Project: Jones Dairy Storage Date: 6/1/2023
Project Number: SDP-23-03
Contact: Garrett Frank, PE, PLA
Phone: (919) 866-4503
Email: Garrett.Frank@timmons.com

Comments from the Town of Rolesville review has been addressed below. Our responses are in red.

REVIEW COMMENTS:

ALTA/NSPS Land Title Survey
 Rivercrest Realty Investors
 Owner: Suzanne Shoaf Ward
 DB 15069 PG 36
 PIN: 1850608722
 Jones Dairy Road
 Wake Forest, North Carolina

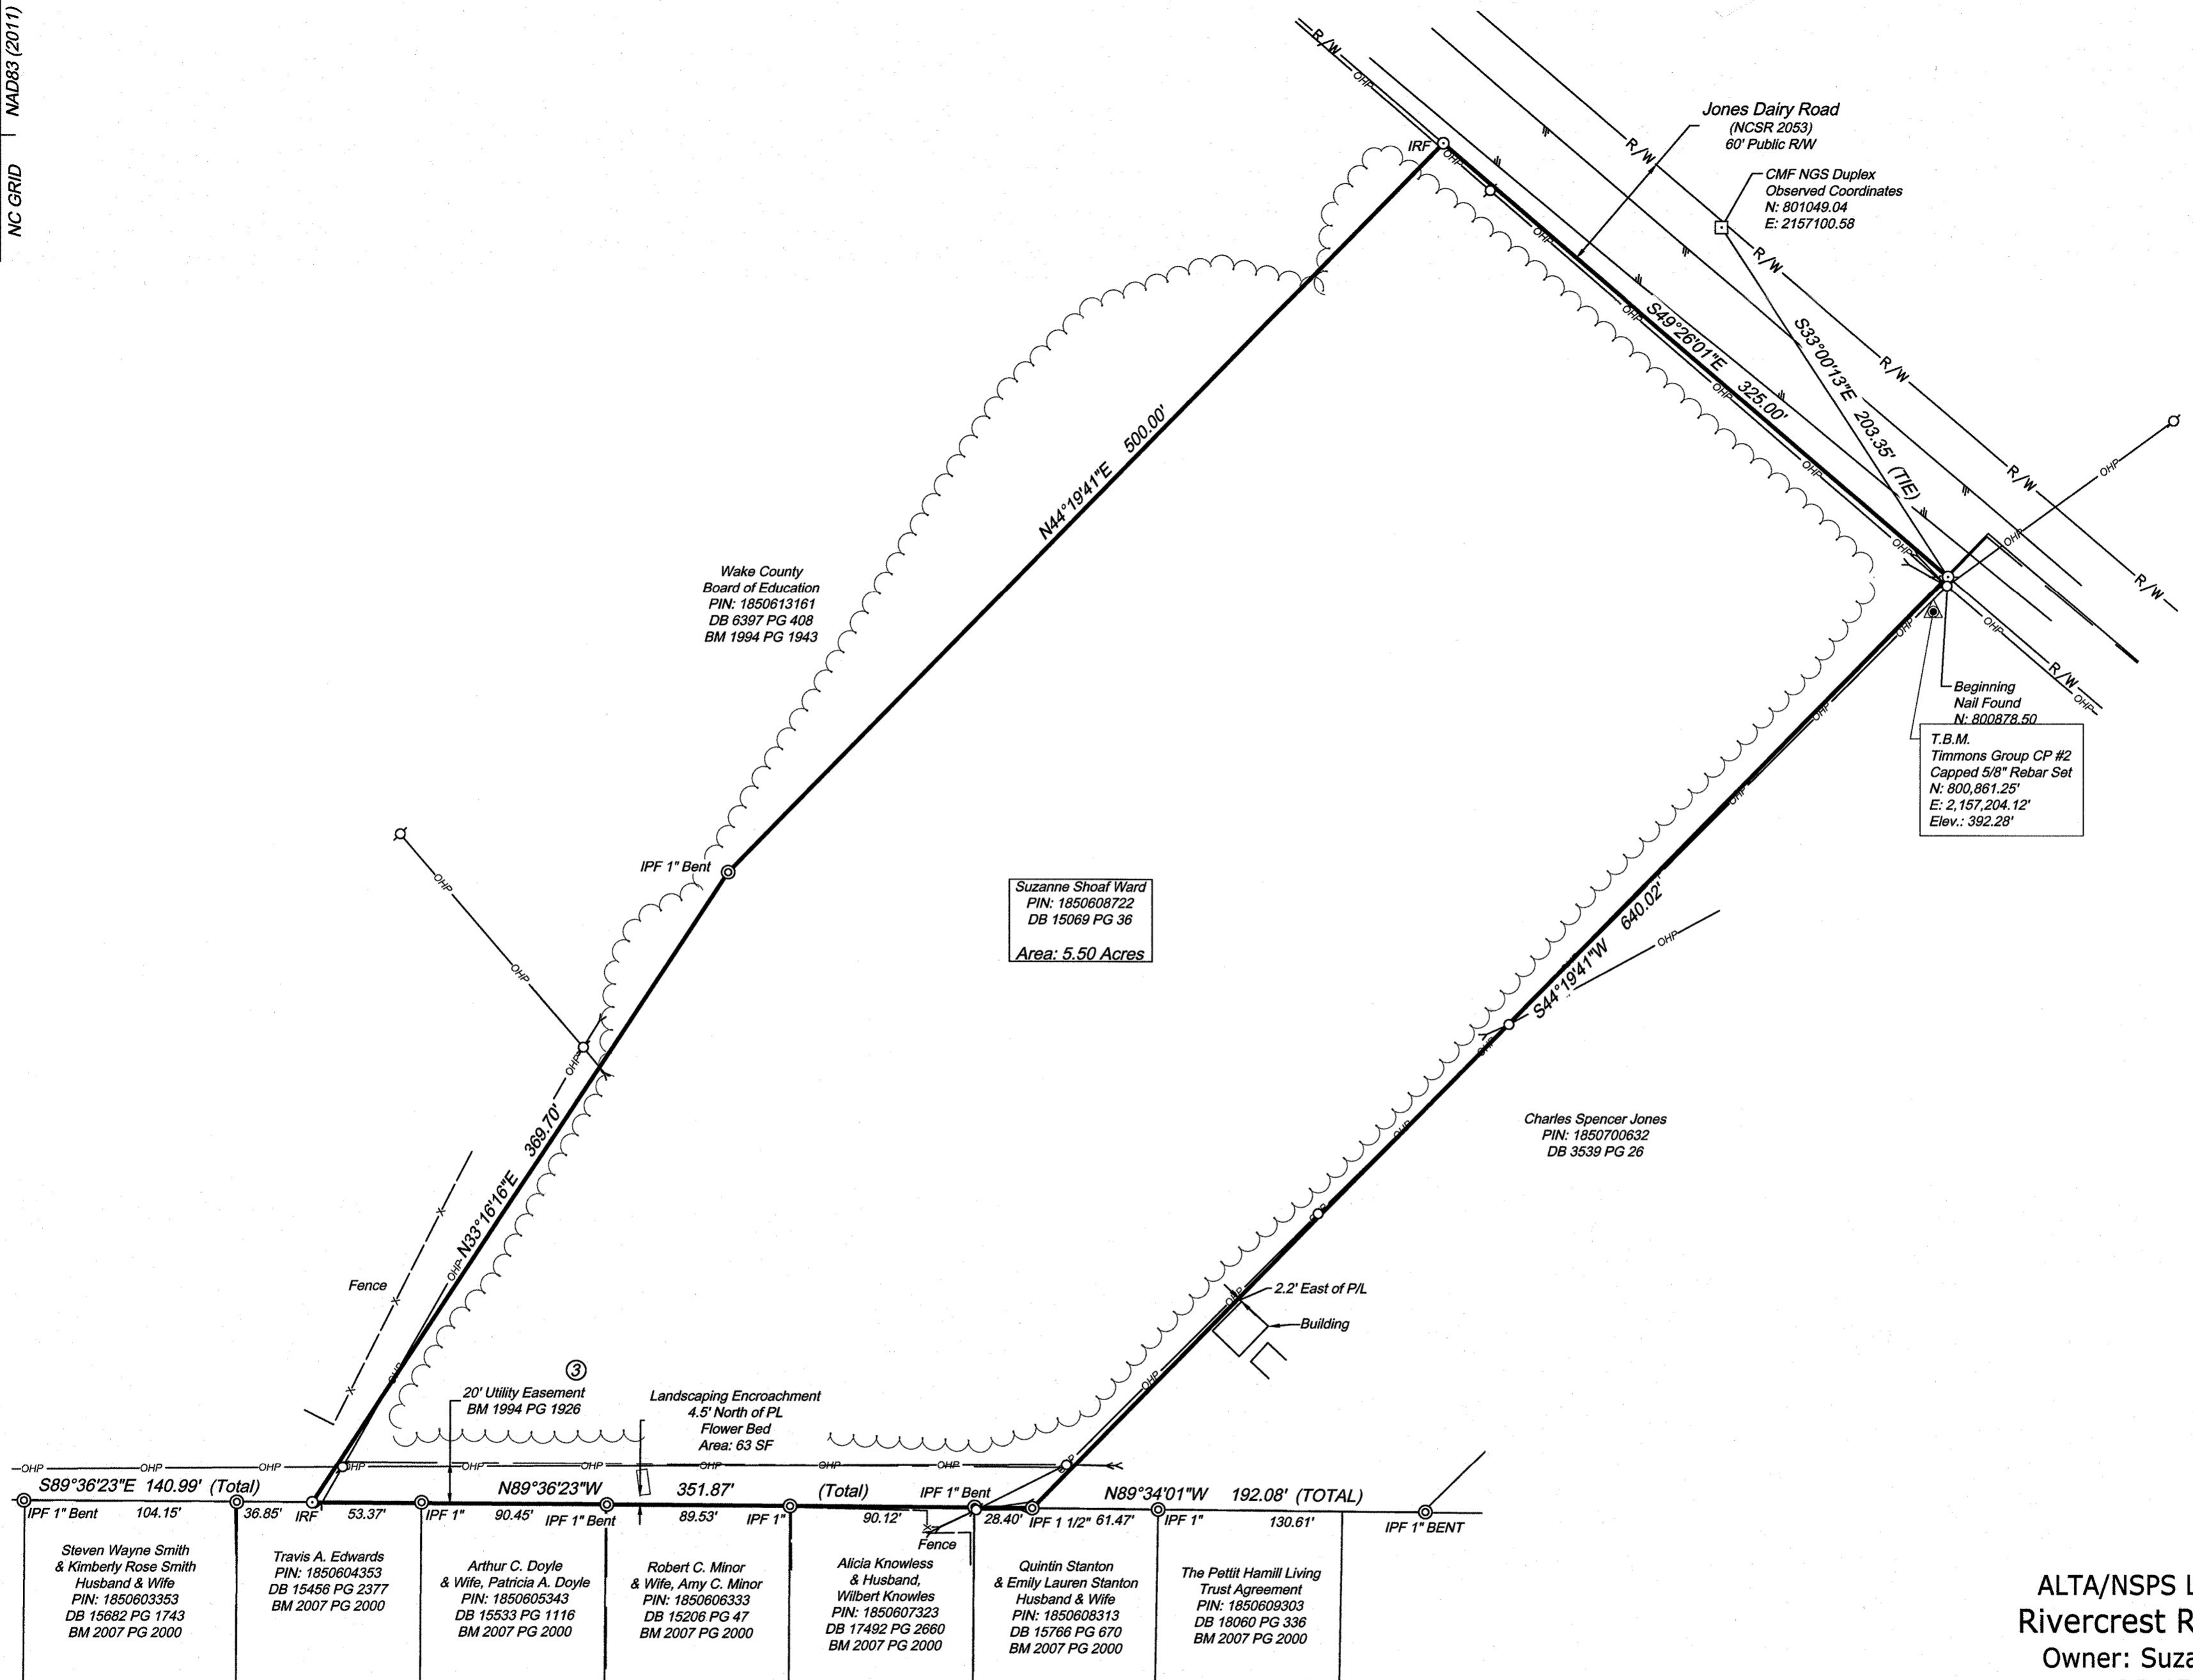
36. Please label all easements including their width and whether public or private.
Response: All easements have been shown and labelled per ALTA Survey. See attached ALTA Survey.
